RE: Integrated Environmental Impact Statement, Tree Conservation Report & Wildlife Mitigation and Monitoring Plan - Zibi Development Phase 1 & 2 - Addendum #1

### Integrated Environmental Impact Statement, Tree Conservation Report & Wildlife Mitigation and Monitoring Plan – Addendum #1

Project:  
ZIBI ONTARIO BLOCK 207

Drawing Title:  
SITE PLAN AND SITE  
STATISTICS

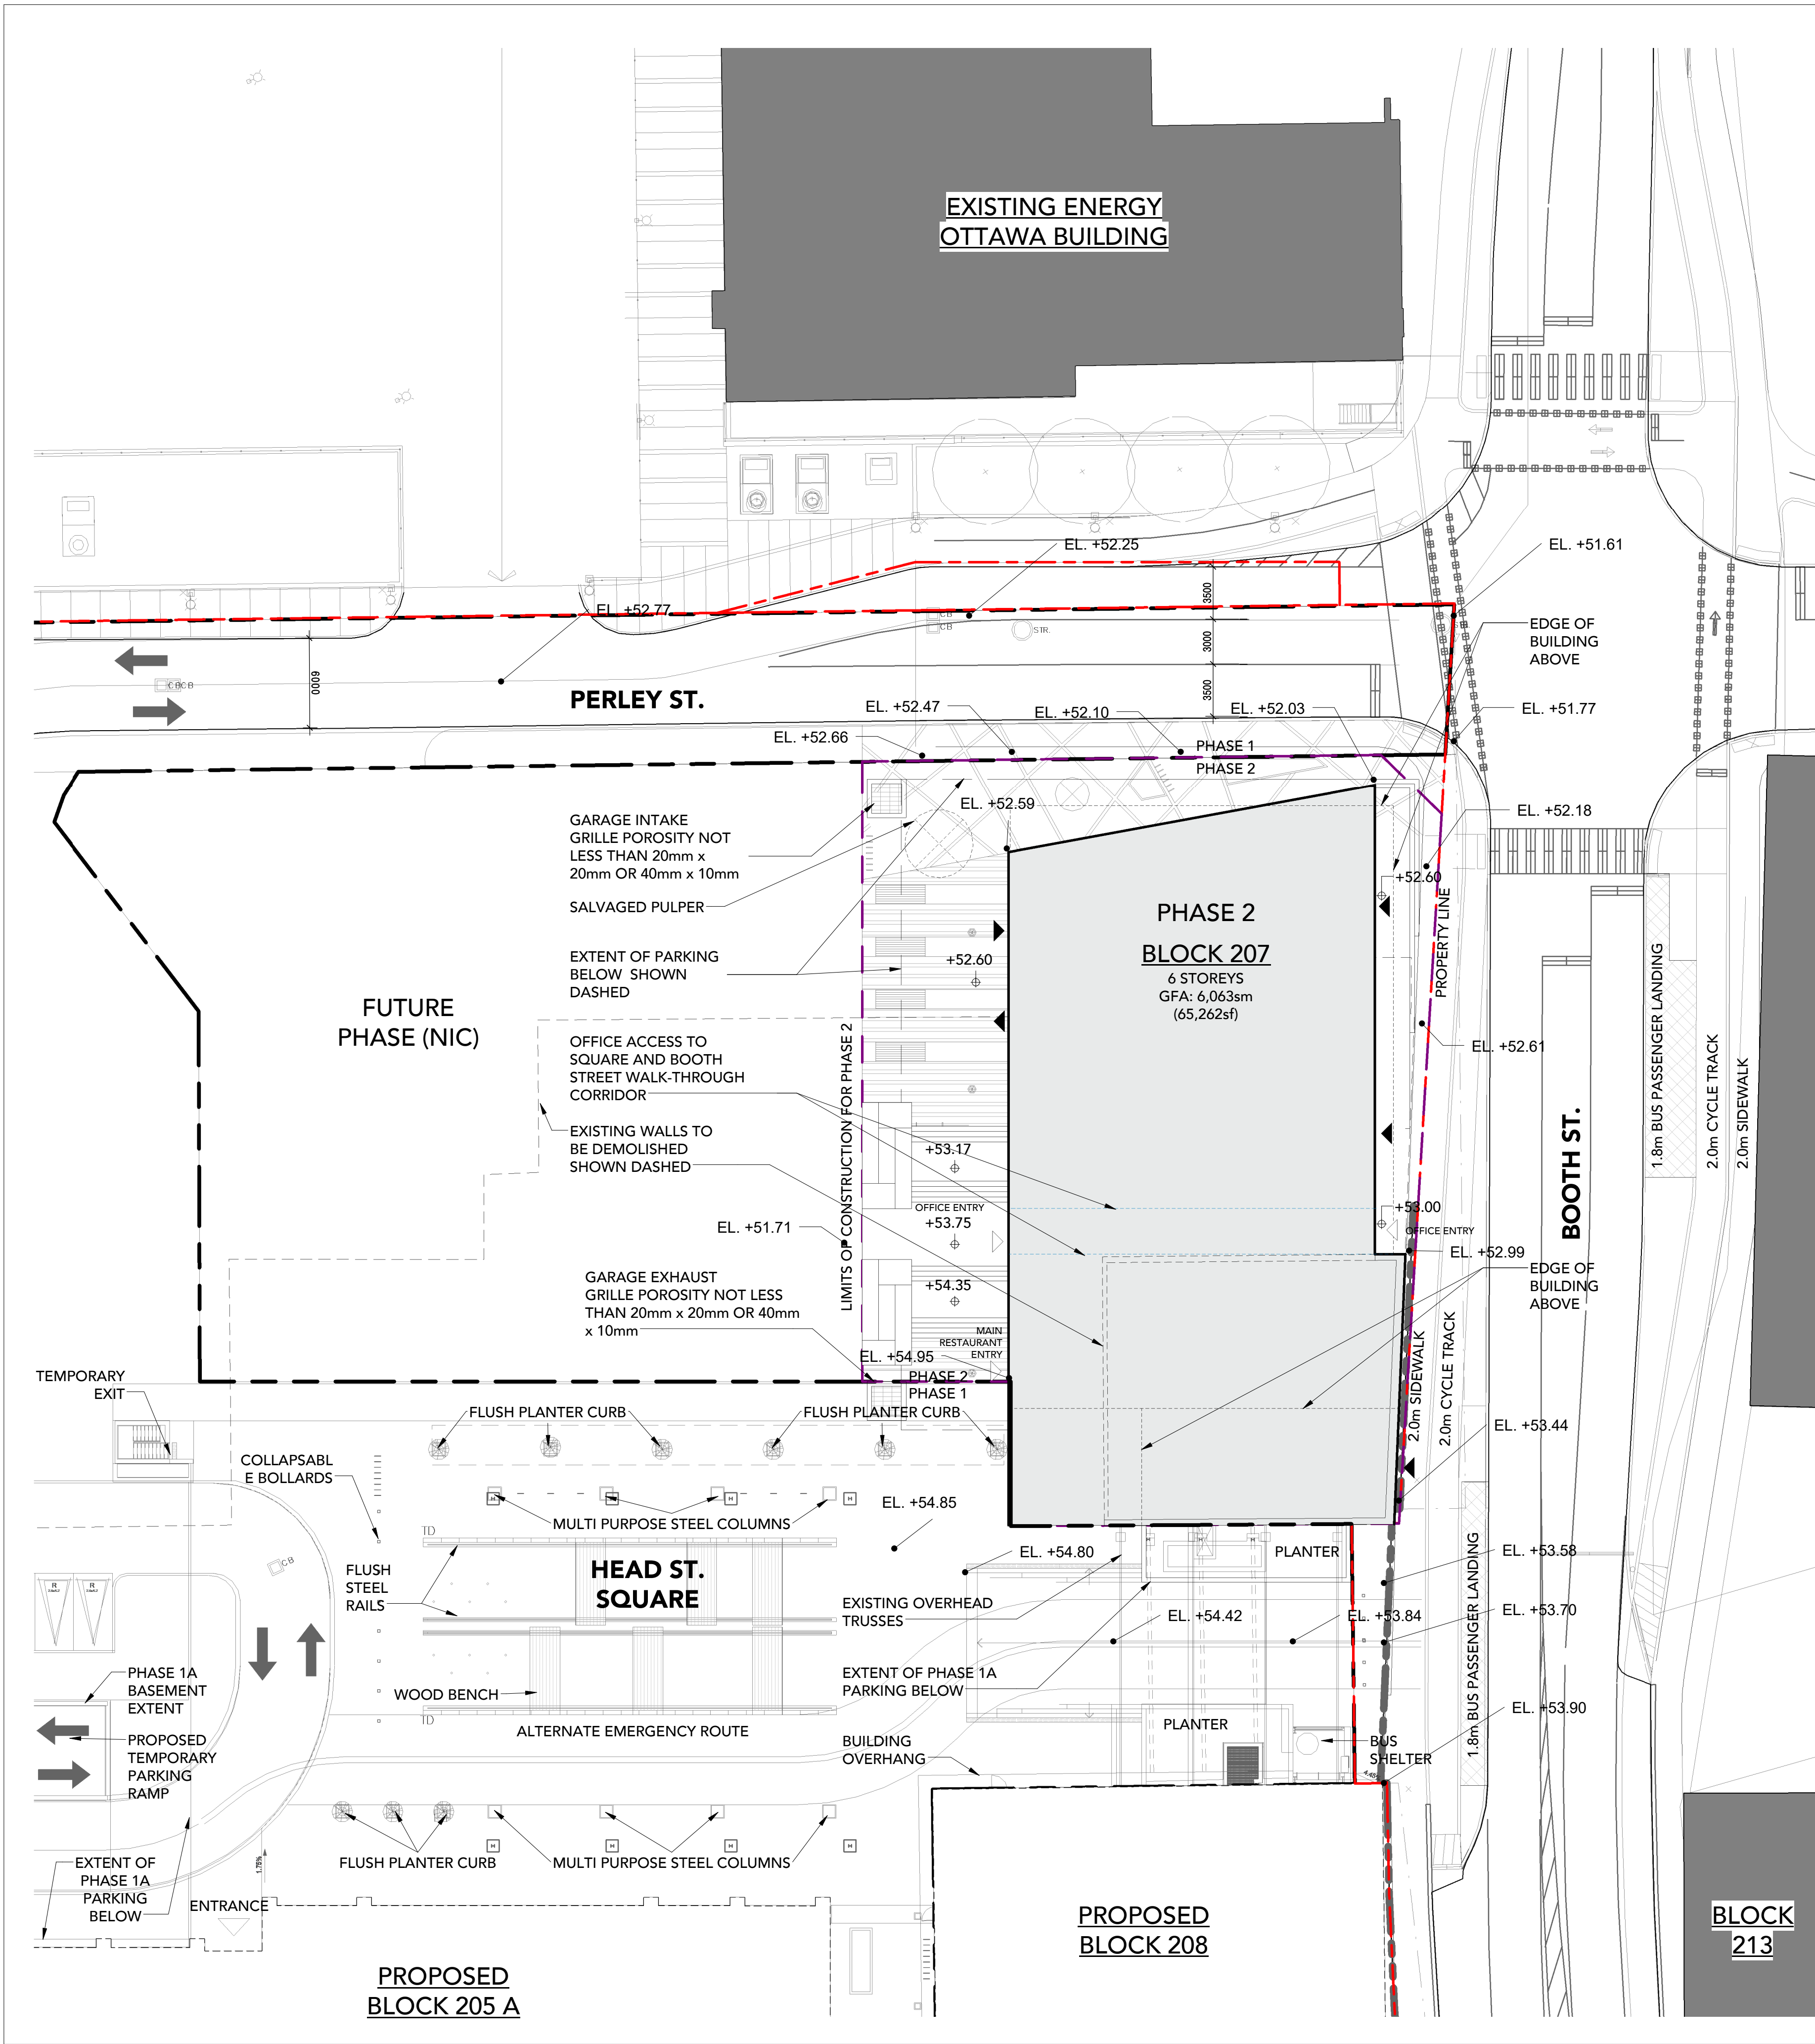
The updated Phase 2 Site Plan is included below. The following description of the Phase 2 development should be interpreted to supersede the description previously included in the Integrated EIS, TCR and WMMP:

Phase 2 will include redevelopment of Block 207 to include a new six (6) floor (6 storey) commercial building with a gross floor area of 6,063 m<sup>2</sup>. Block 207 has an area of approximately 0.45 acres. The new six (6) storey building will include space for retail, restaurant(s), and commercial offices. Two (2) levels of underground parking with seventy two (72) underground parking spaces and twenty four (24) bicycle parking spaces are included in the Site Plan. The new six (6) storey building will incorporate portions of the south and east walls of the existing building within Block 207. Phase 2 will also include construction of the pedestrian alley located to the west of Block 207. The Zibi Phase 1 & 2 development will receive municipal water and sewer services. Stormwater quality control will be provided by a new end-of-pipe oil and grit separator.
